PLANNING COMMISSION STAFF REPORT

Central Park Condominiums conditional use
(410-07-40) and preliminary condominium (480-
08-04) at 1357 – 1381 South Main Street

March 26, 2008

SHEET NUMBER
 A100

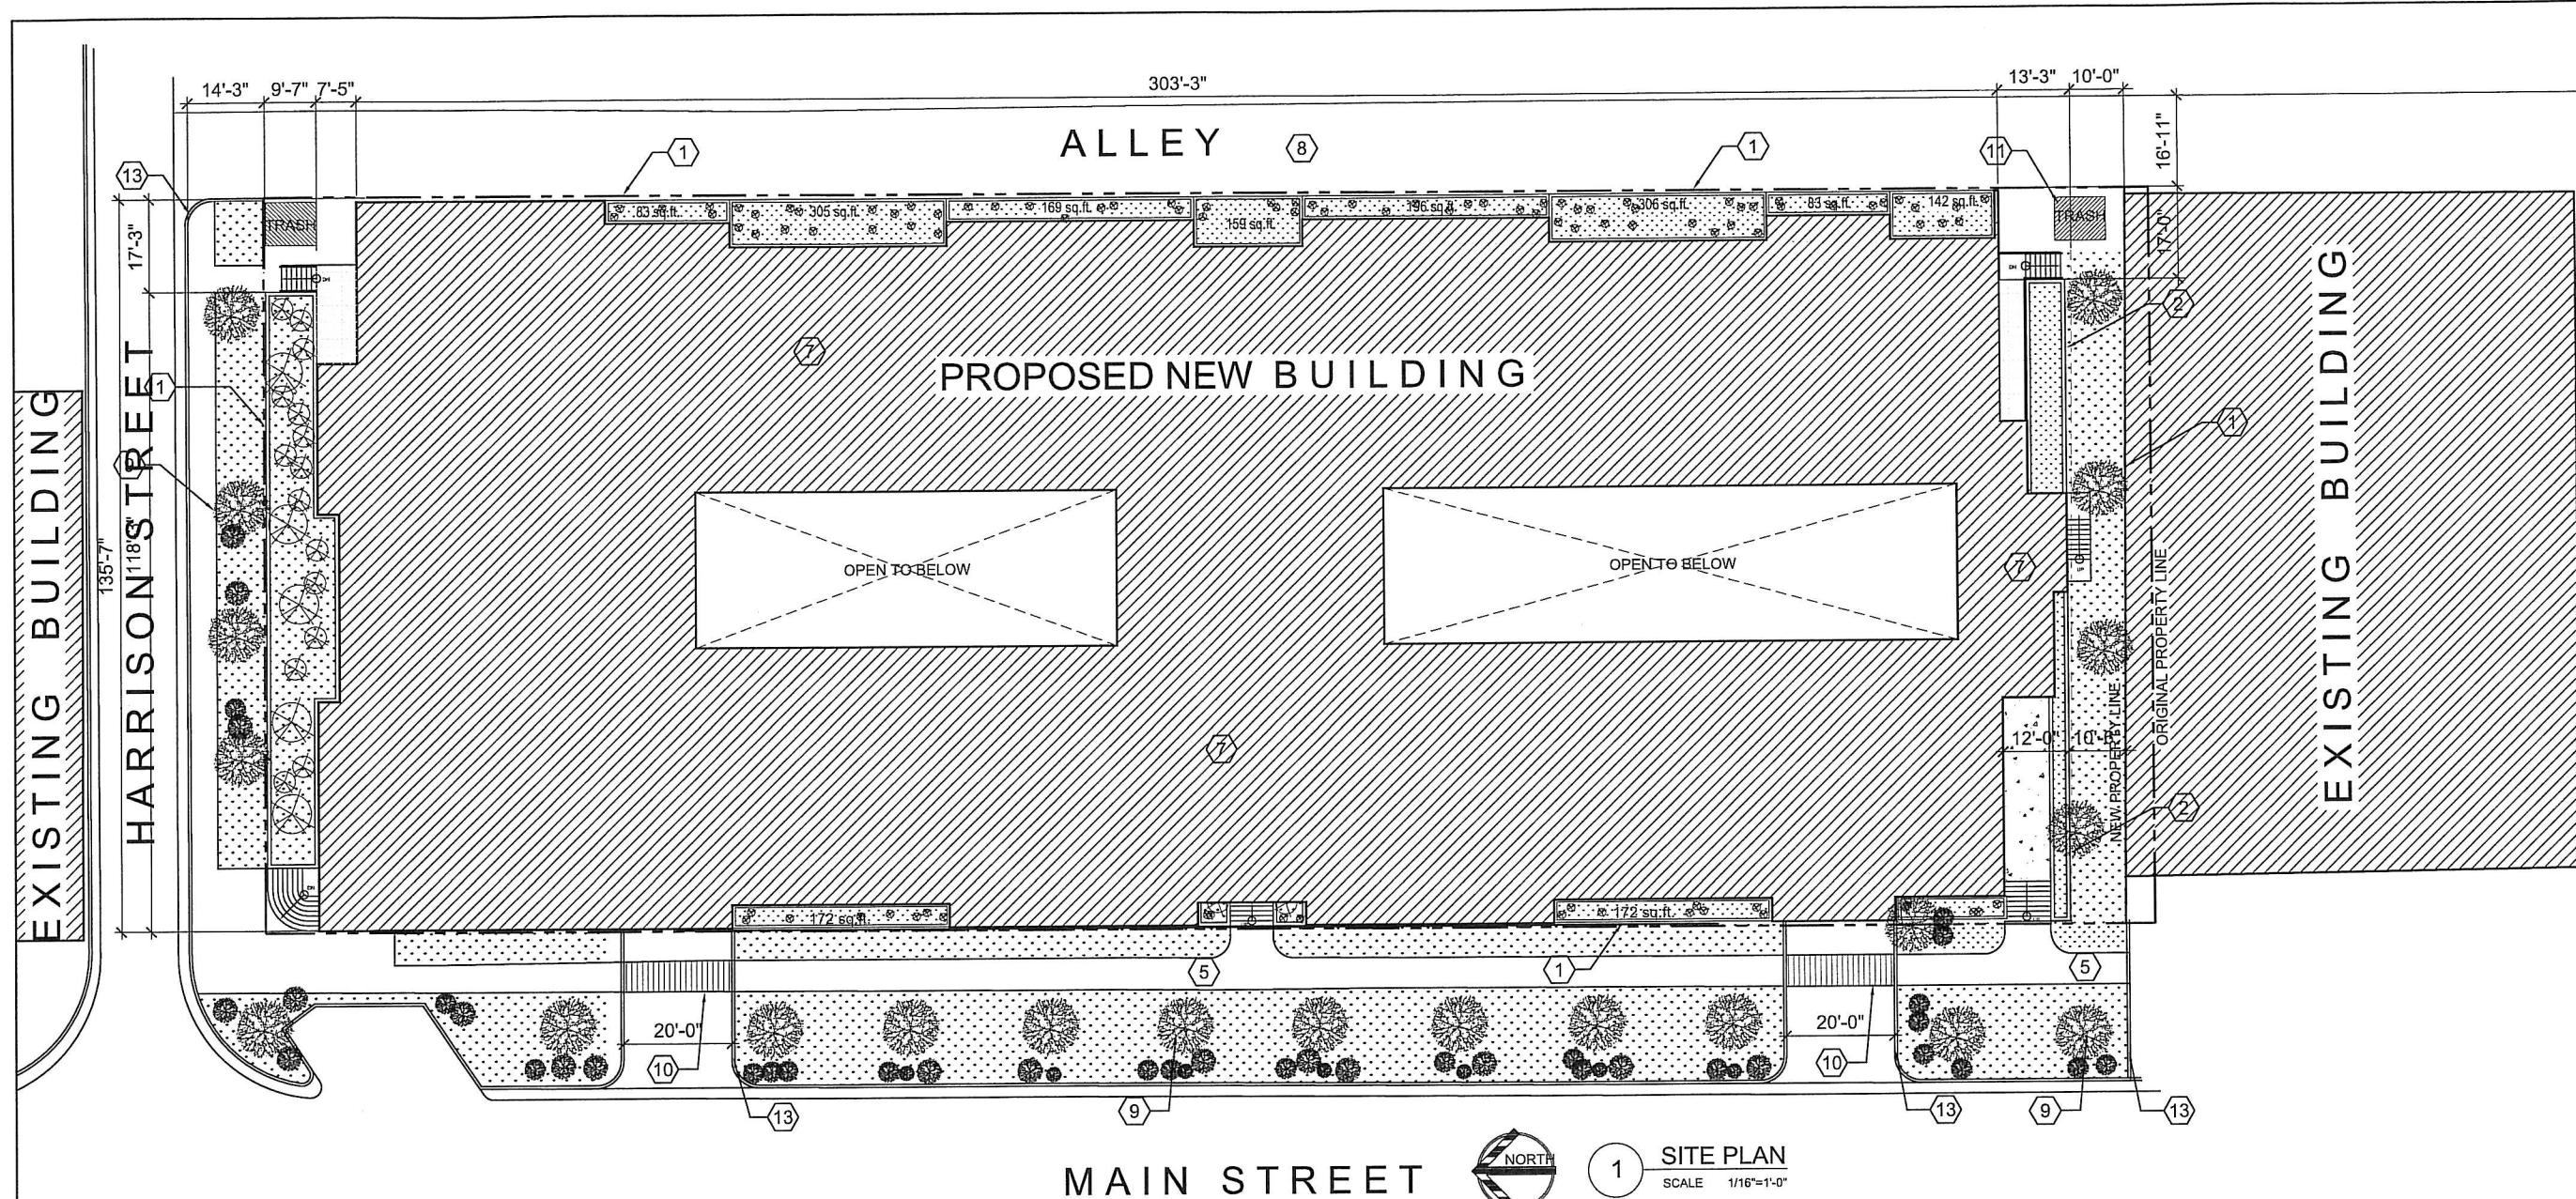
Sheet A100 notes parking calculations of 81 unit with 120 stalls required and provided, to include the 5 ADA stalls as well as the 5% bike provision, of 6 stalls.

A102

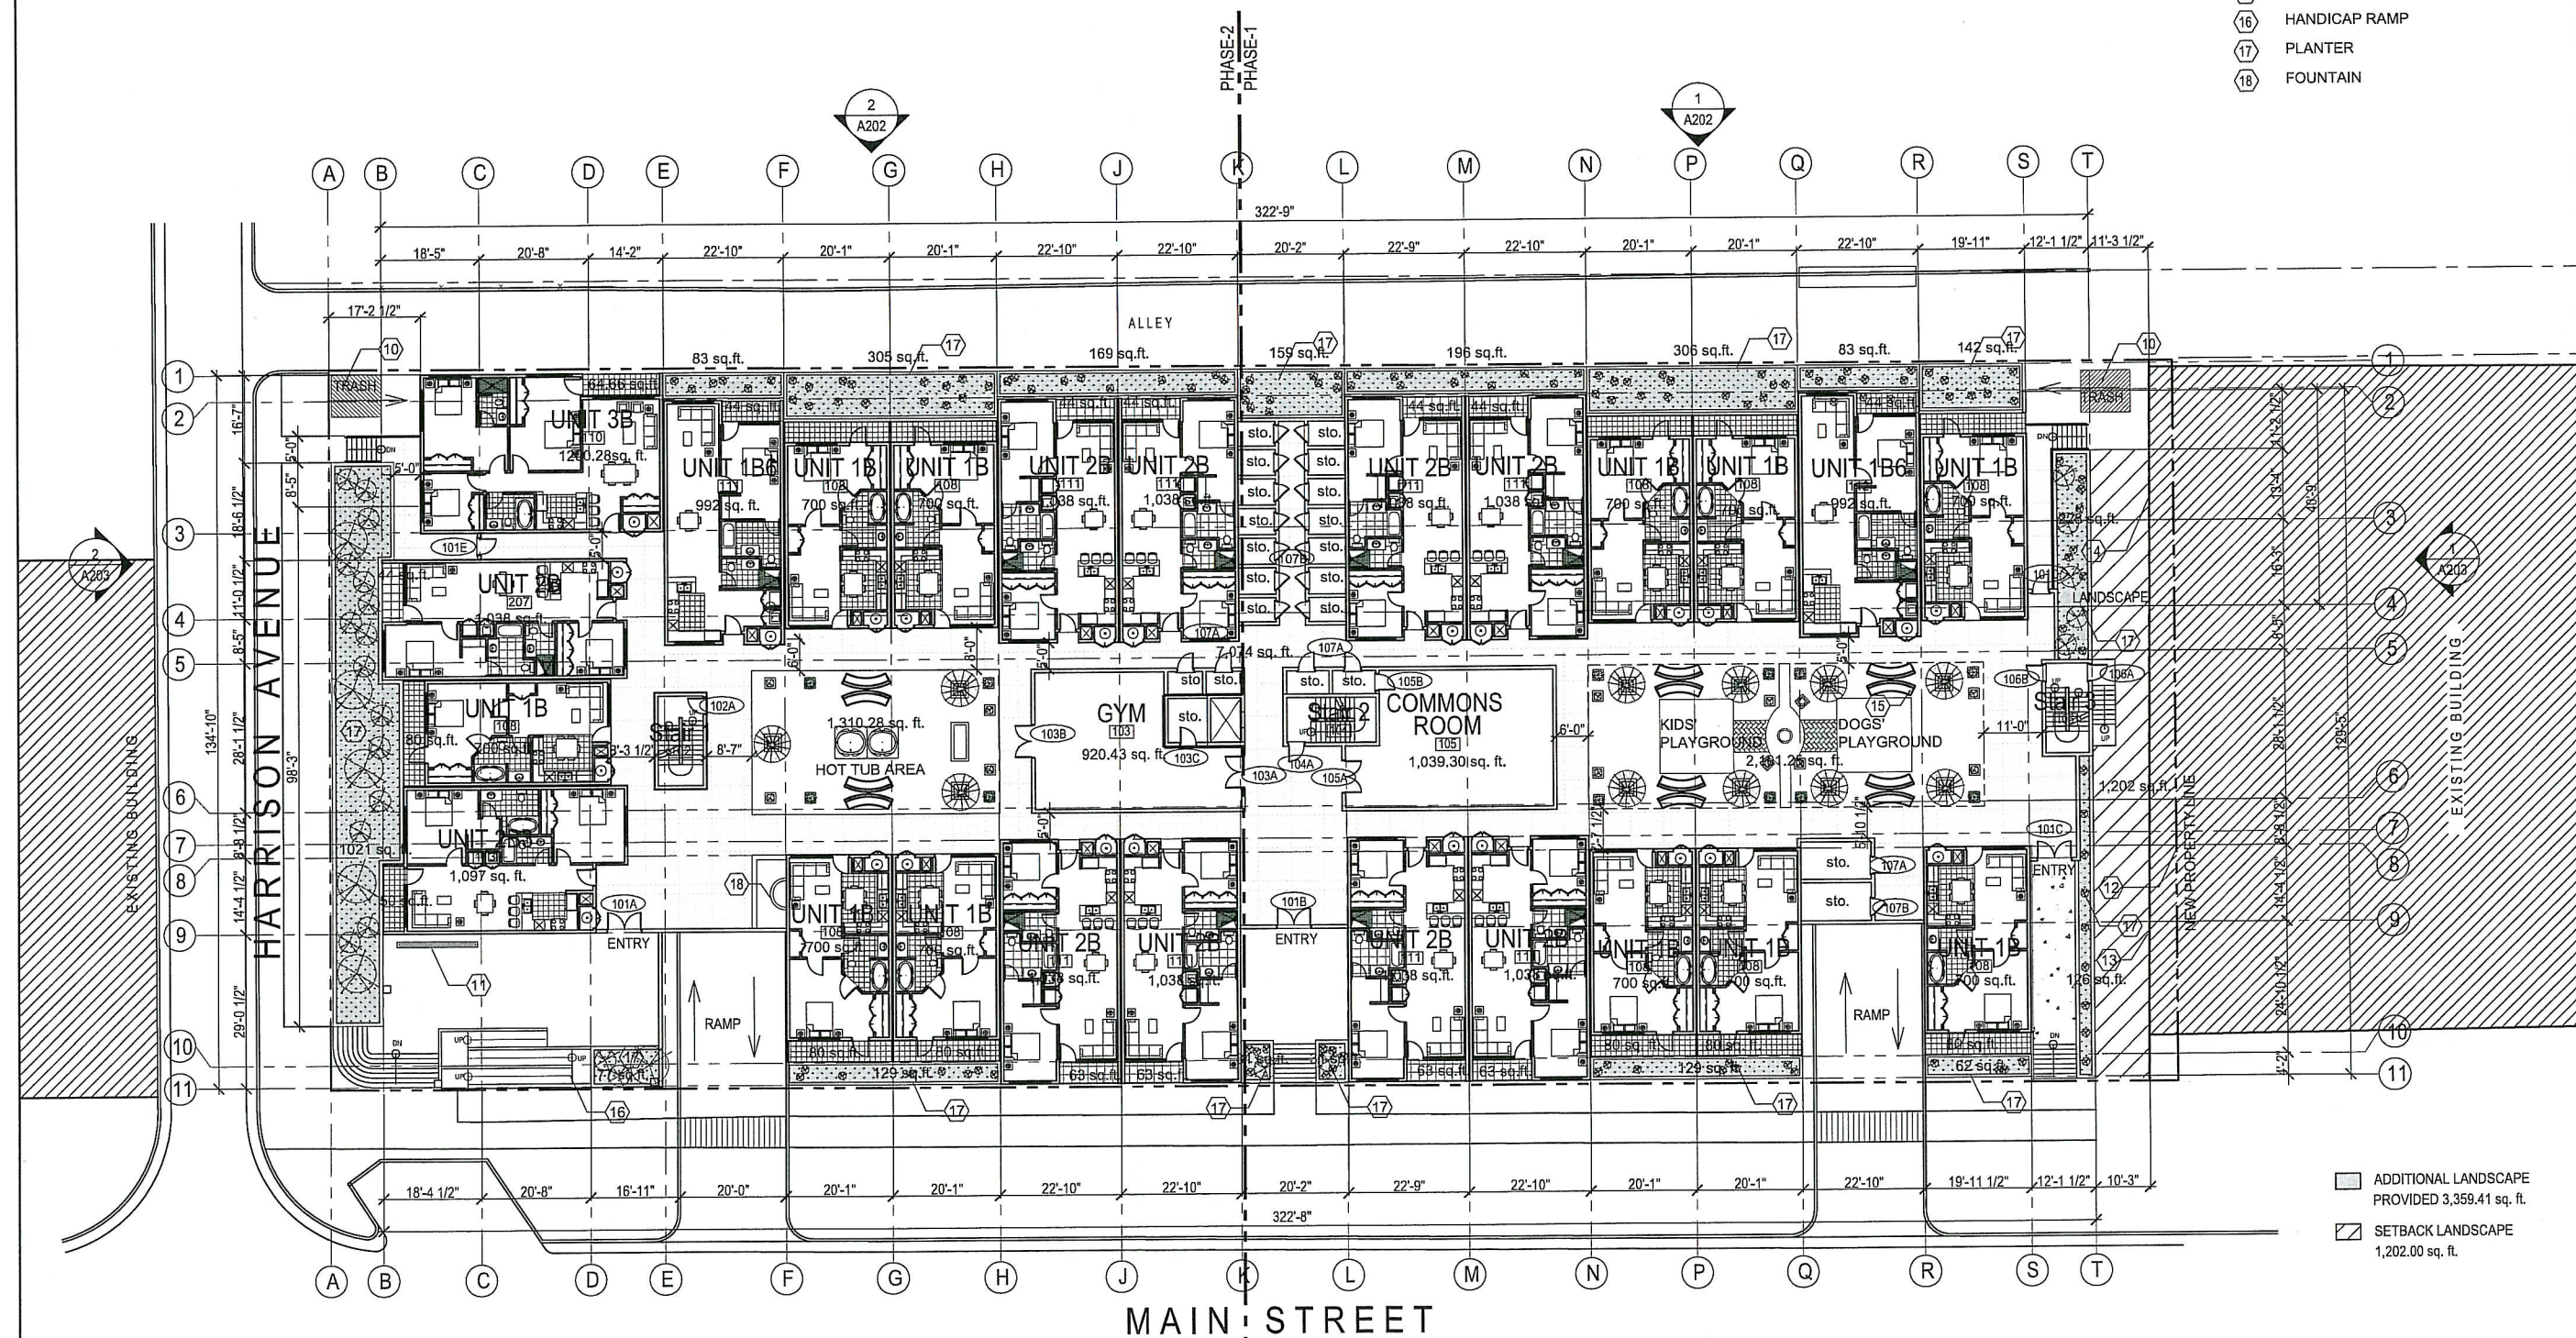
The Architectural plan sheet A102 has revised the ramp area to 28 feet from building face proposing to match the proposed Civil parking level ramps.
